**Ferret
Exploration
Company of
Nebraska, Inc.**

Enclosed please find corrected replacement pages for the Application and Supporting Environmental Report for USNRC Commercial Source Material License. Please replace the original pages with the corrected pages. These changes were made as a result of the NDEC completeness Review.

ERRATA SHEET
DEC Completeness Review

REV. DATE	FERRET OF NEBRASKA, INC.	
	CROW BUTTE PROJECT Dawes County, Nebraska	
	ENGLISH CREEK AND SQUAW CREEK WATERCOURSES	
	PREPARED BY: F.E.N.	
	DWN. BY: JC	DATE: 8/87
		FIGURE: 4.4-1

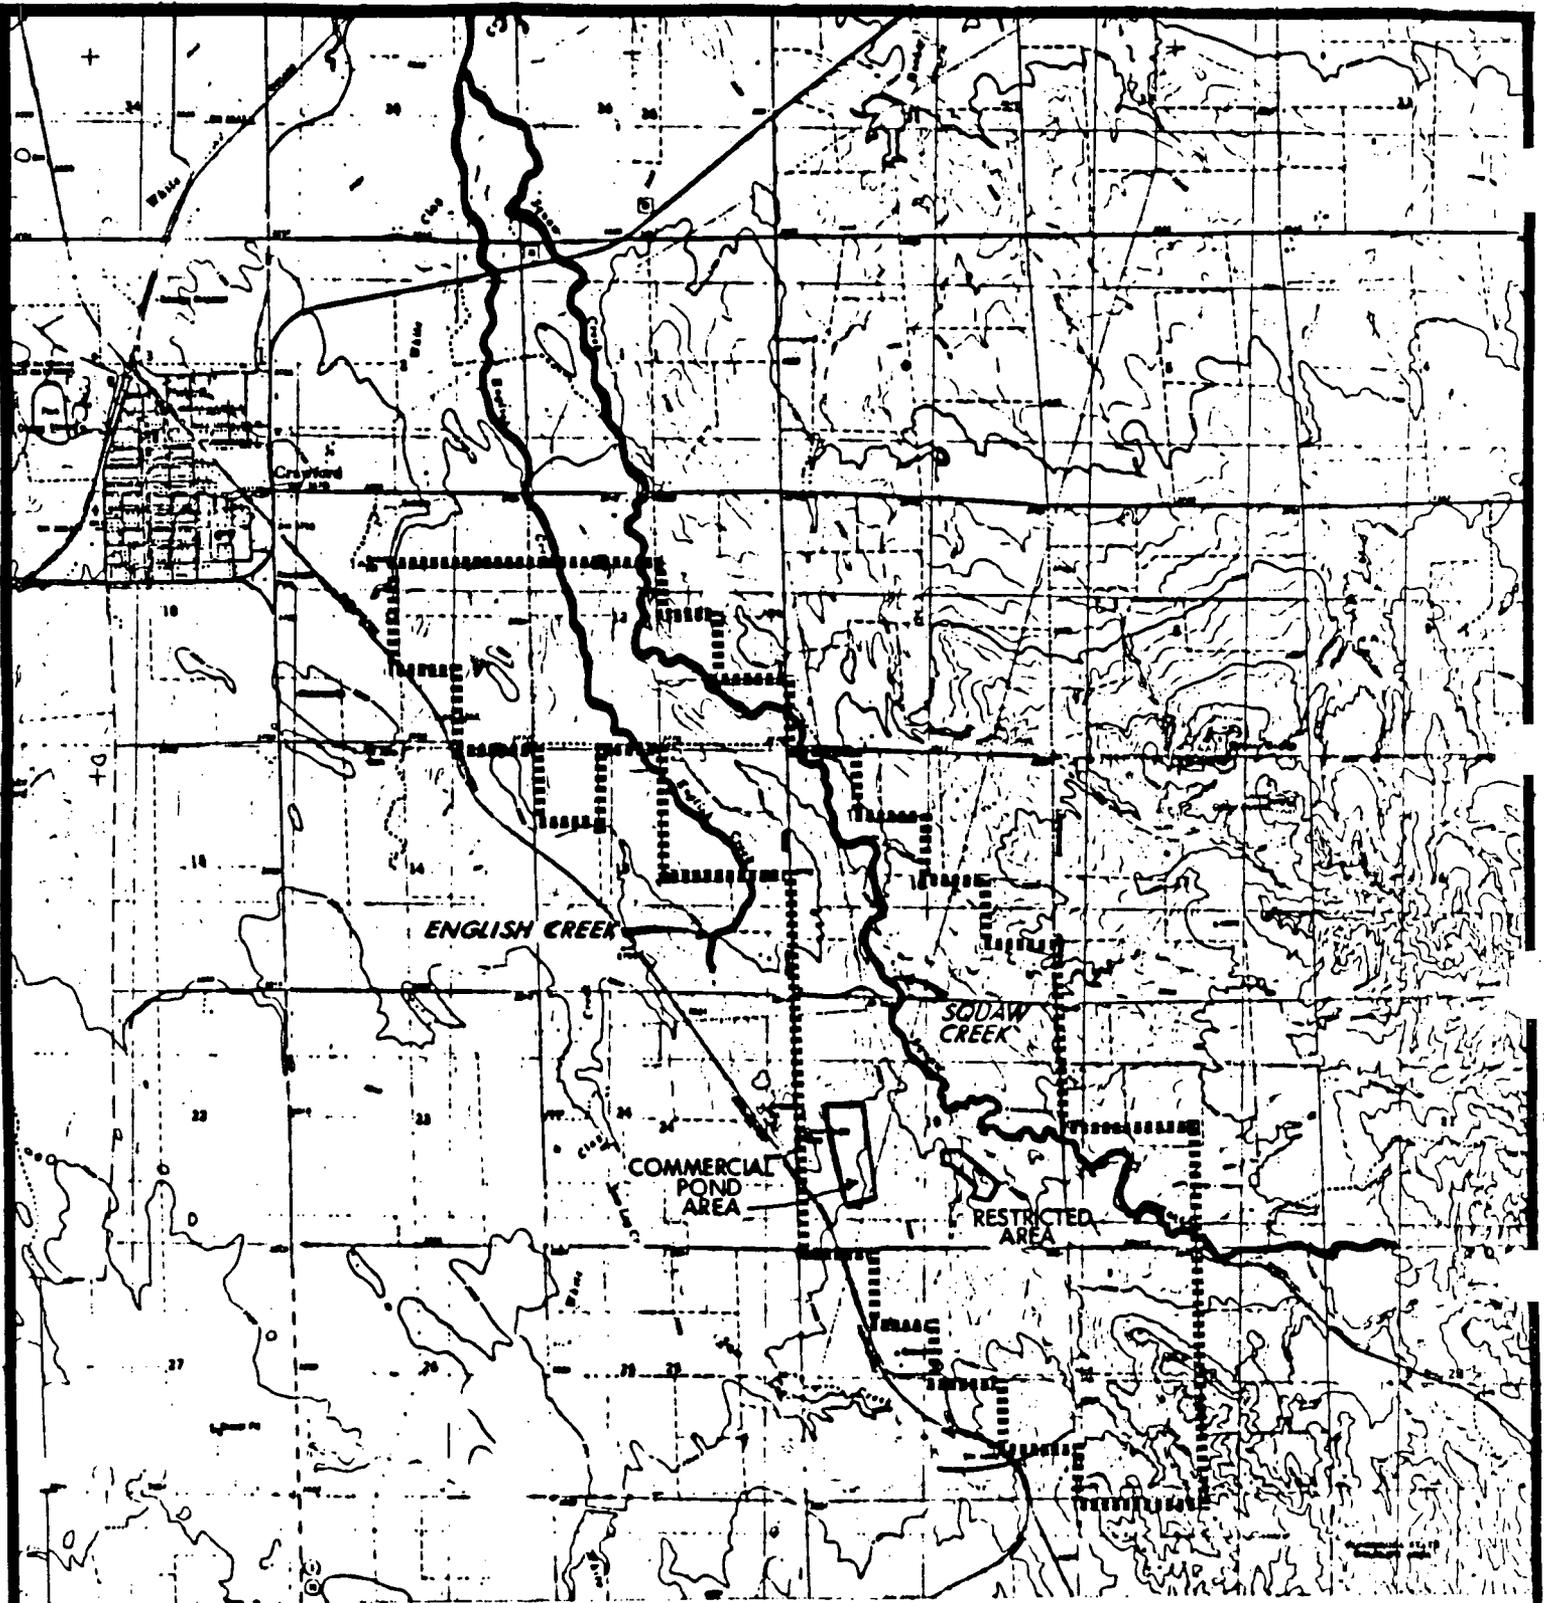
1. The following permits or construction letters must be added on Page 1 of the introduction:
Class V 5W-11
Septic Tank
Pond Permit
Water Resources Permit
2. Page 4.4(3); Figure 4.4-1, no scale.
3. Page 4.4(14); toward is misspelled.
4. Page 4.4(16); Figure 4.4-7, no scale.
5. Page 4.5(22); typing error; should read "the".
6. Page 4.5(25); P. 3 L4-5, are there some words missing?
7. Page 4.7(15); local economy has misplaced comma.
8. Page 4.8(3); L2-3 should read "published" instead of "publisted?"
9. Page 4.8(53); P.2 L1 feature number is missing.

Items 1-9 have been added or corrected on the appropriate pages.

Scales have been added to these Figures.

REV. DATE	FERRET OF NEBRASKA, INC.	
	CROW BUTTE PROJECT Dawes County, Nebraska	
	LOCATION MAP	
	PREPARED BY: F. E. N.	
	DWN. BY: J. C.	DATE: 8/5/87
		FIGURE: 4.4-7

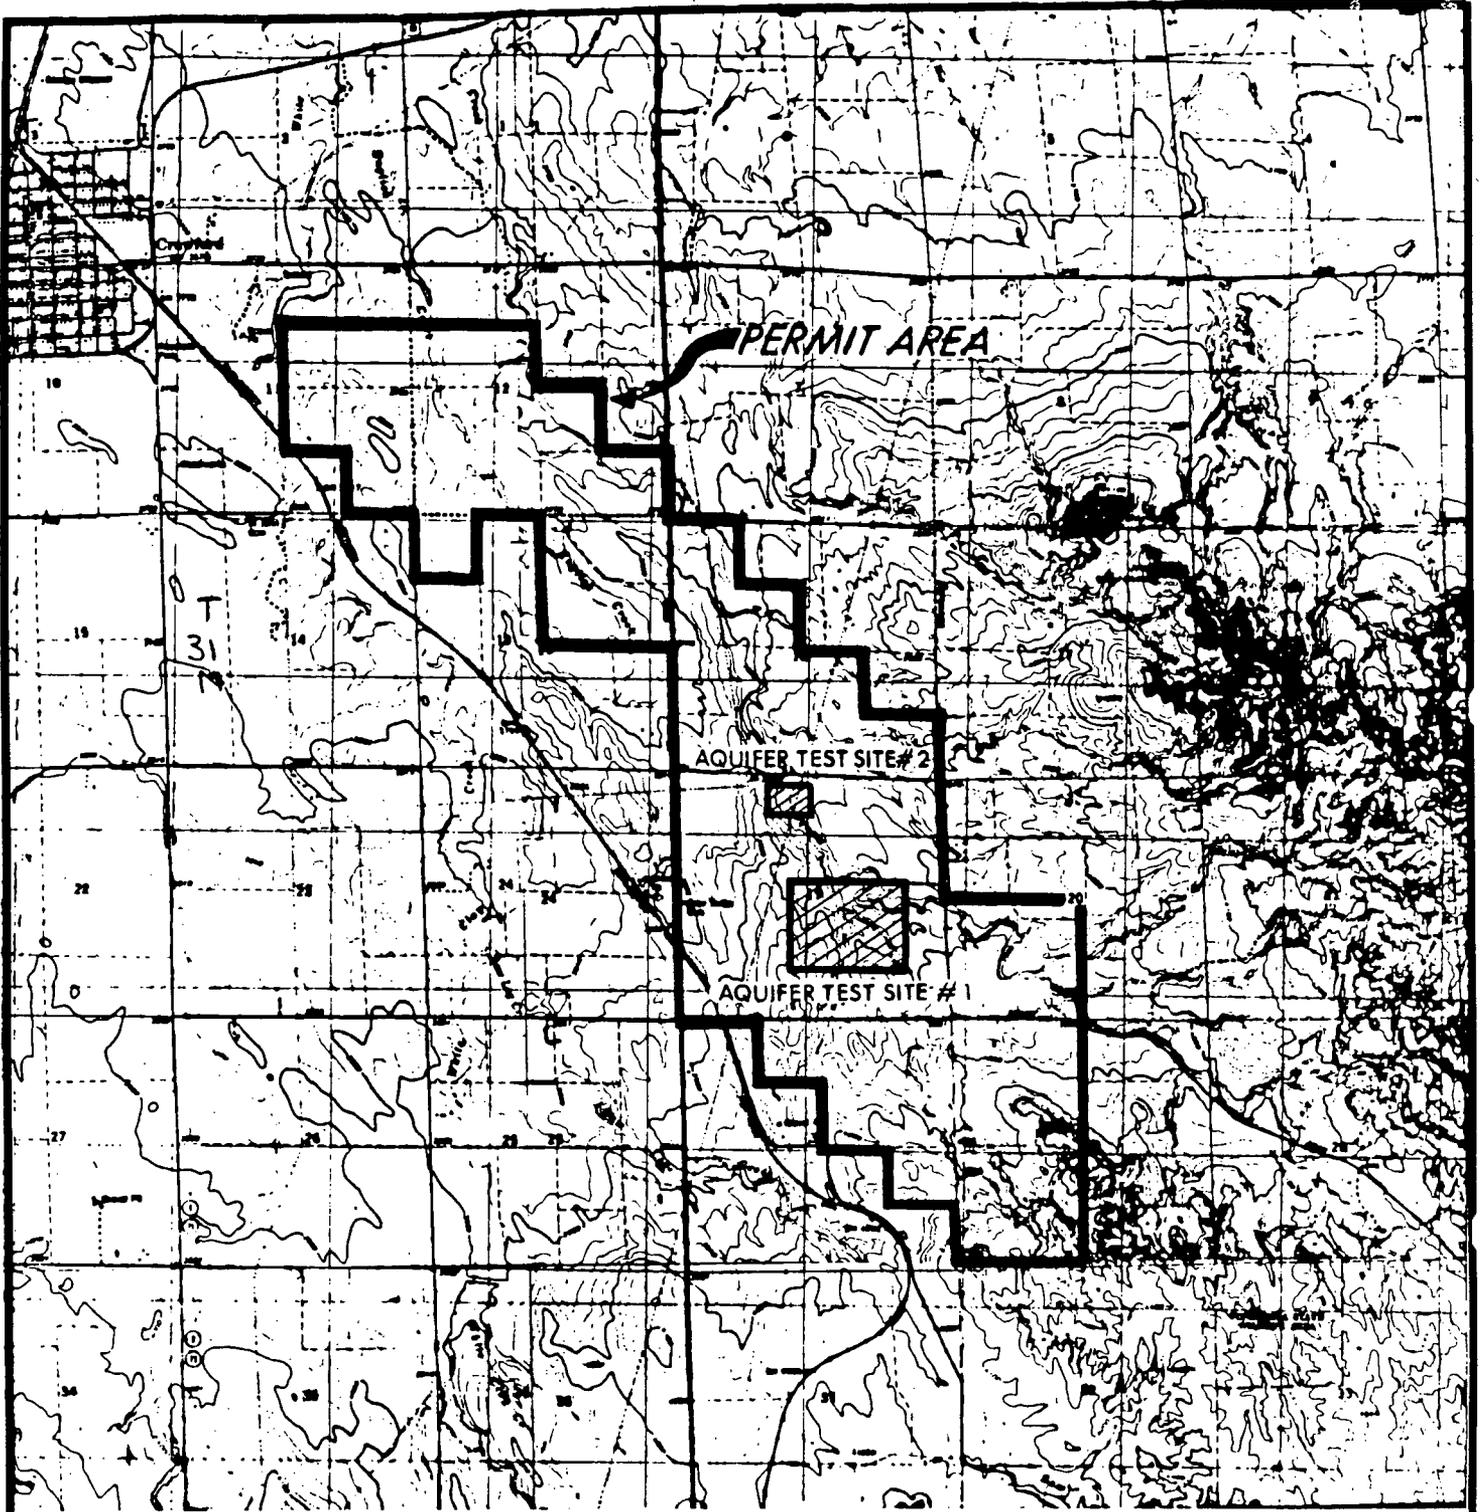
- PSF
1. Correction page 3.0(1) attached and page 1 of Introduction
 2. Corrected Figure 4.4-1 attached
 - 3.* Corrected page 4.4(14) attached
 4. Corrected Figure 4.4-7 attached

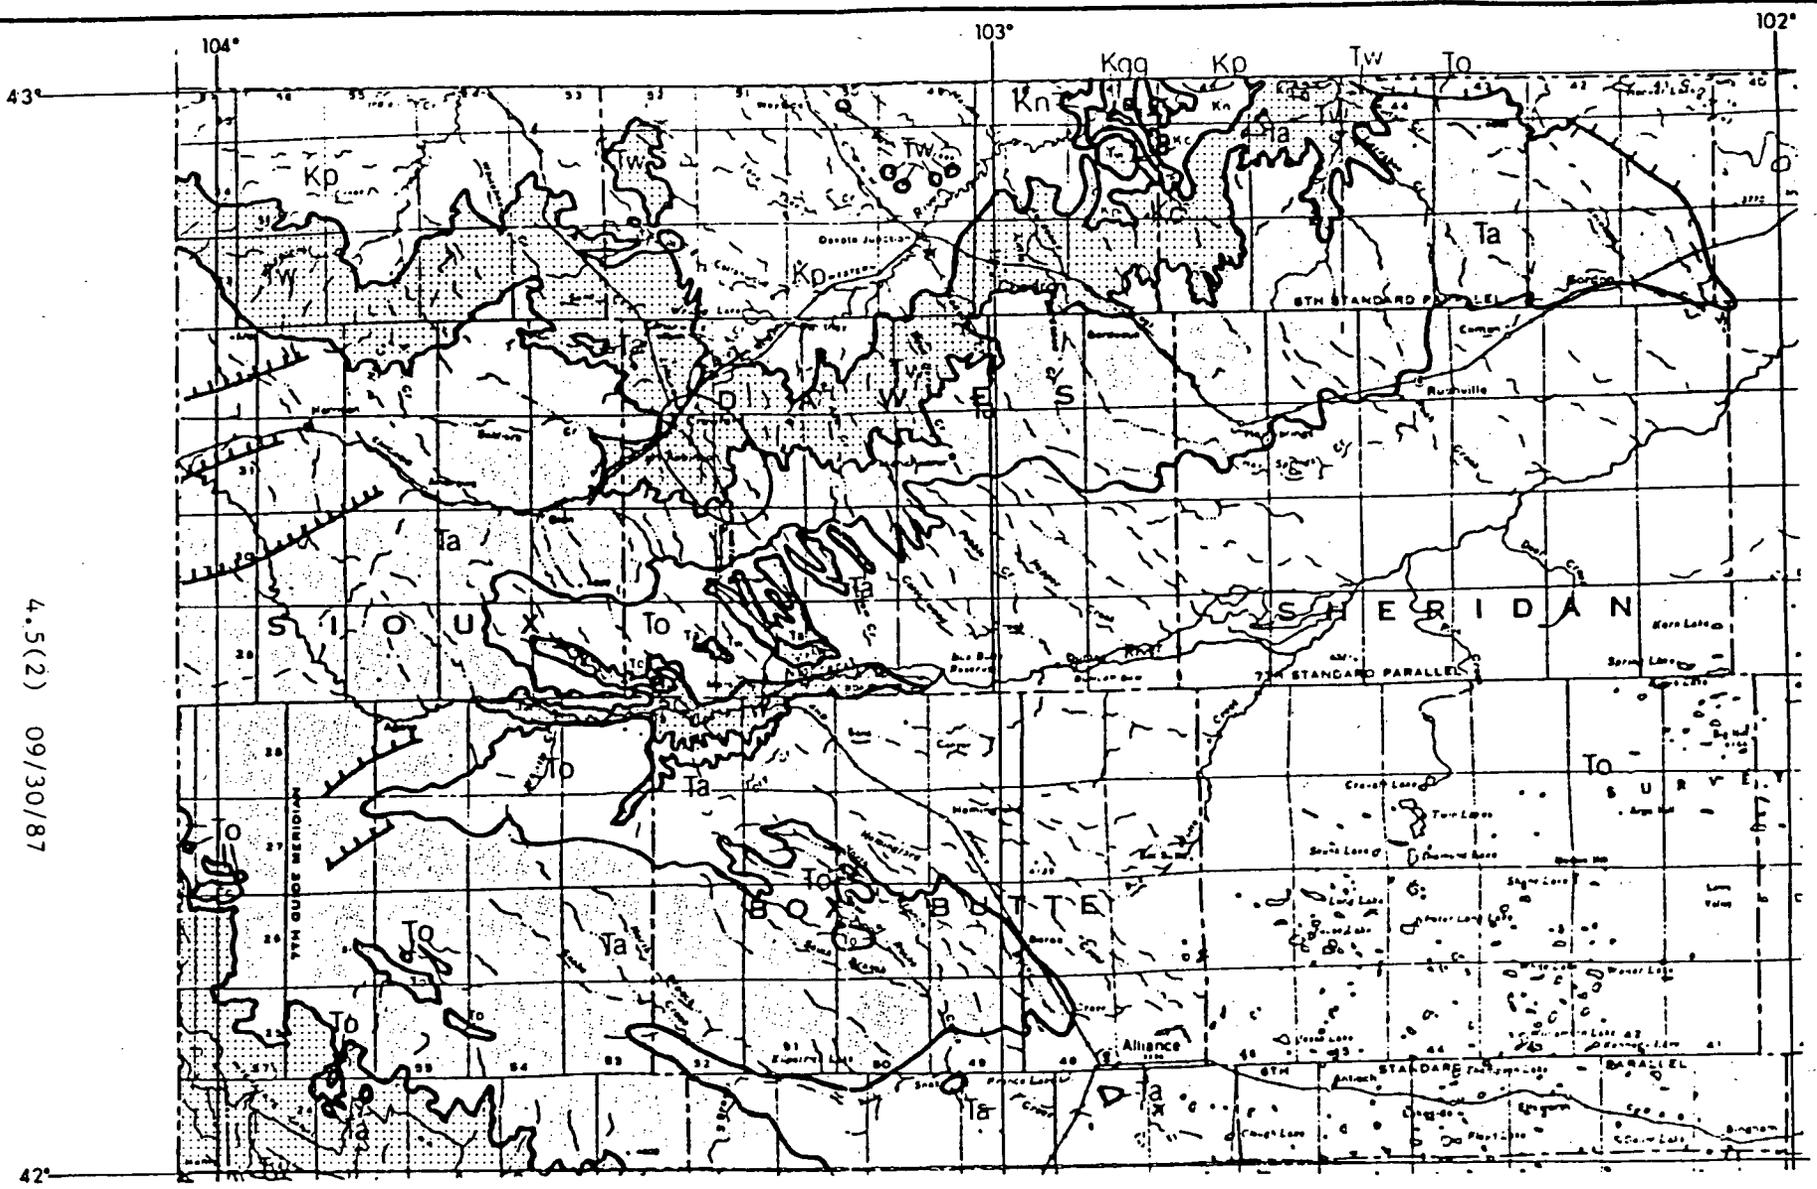
2. Subsection 4.5, Geology
p.4.5(2), Figure 4.5-1. Figure has been reduced to a point where it is unreadable. Needs to be redone.

p.4.5(8) to 4.5(10) Regional Structure. FEN's interpretation of the regional structure needs to be shown on a map. Figure 4.5-1 is inadequate. The map should include features such as (1) Crawford Basin, (2) Inner Crawford Basin, (3) White River Fault, (4) Cochran Arch, (5) Toadstool Park Fault, (6) Bordeaux Fault, (7) Pine Ridge Fault, (8) Chadron Arch, etc.

FEN has included the State Geologic Map of Nebraska as Figure 4.5-1 as the accepted regional structure.

REV DATE	FERRET OF NEBRASKA, INC.	
	CROW BUTTE PROJECT Dawes County, Nebraska	
	STRUCTURE ELEVATION OF Kp CONTACT TOP OF PIERRE (Base of Chadron Formation)	
	PREPARED BY: F.E.N.	
	DWN. BY: JC	DATE: 8/87
		FIGURE 4.5-13

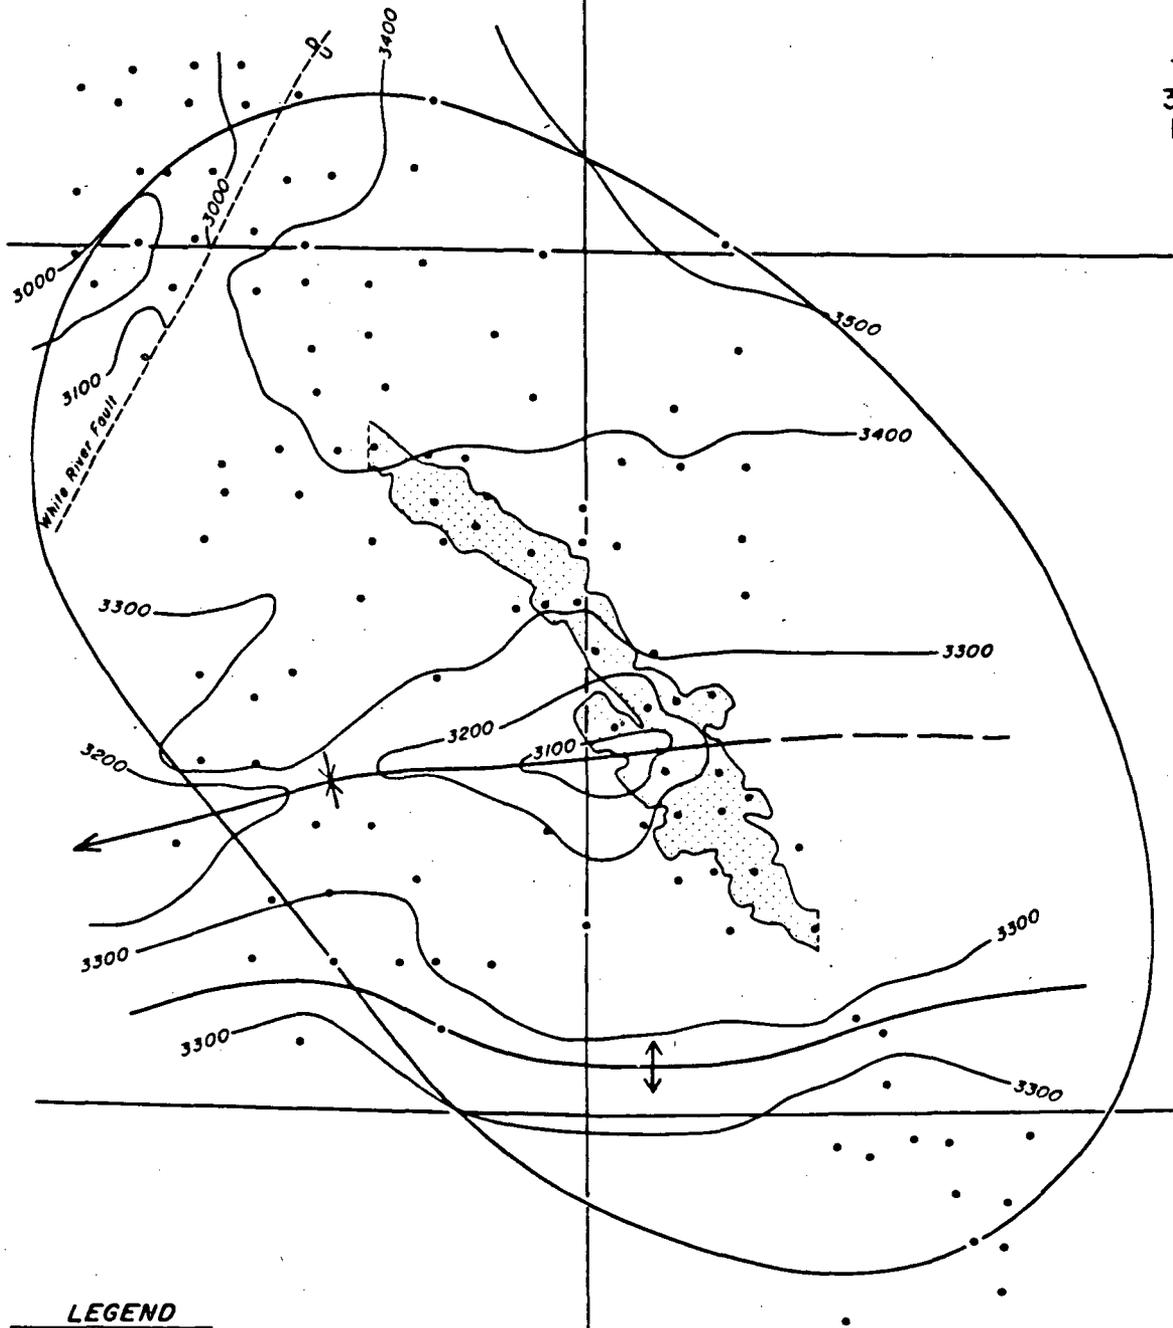
21. p.4.5(28), Figure 4.5-13: Should the structure map (Top Pierre) show anticlinal and synclinal axes? Are these actually folds or erosional highs and lows not related to folding?

REV DATE	FERRET OF NEBRASKA, INC.	
02/16/88	CROW BUTTE PROJECT Dawes County, Nebraska	
	EARTHQUAKE EPICENTERS IN NEBRASKA	
	PREPARED BY: F.E.N.	
	DWN. BY: JC	DATE: 8/87
		FIGURE 4.5-15

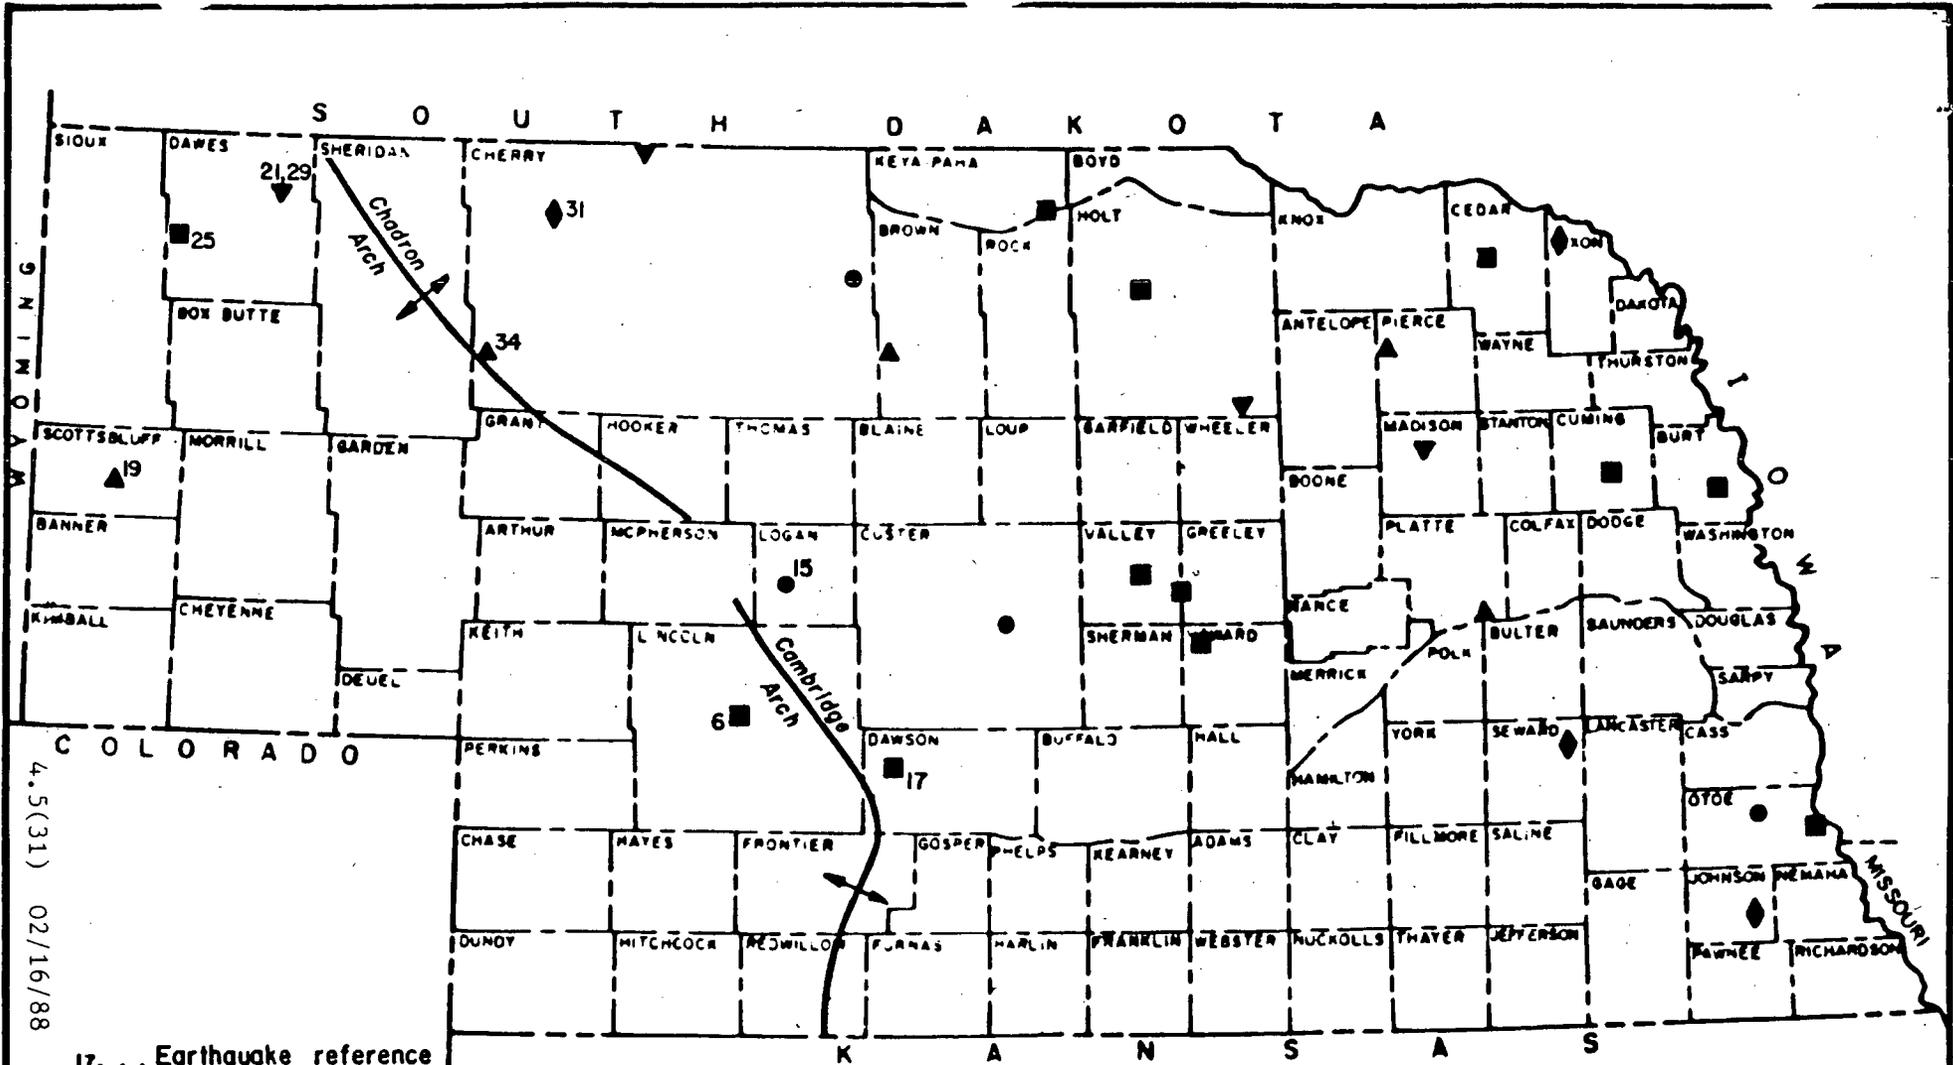
15. Section 4.5 replaced
 16. See page 4.6(3) and page 1 of Introduction
- JA
1. Figures 4.2-1 replaced earlier; Figures 4.4-1 and 4.4-7 replaced by PSF #2 and PSF #4; Corrected Figure 4.5-15 attached
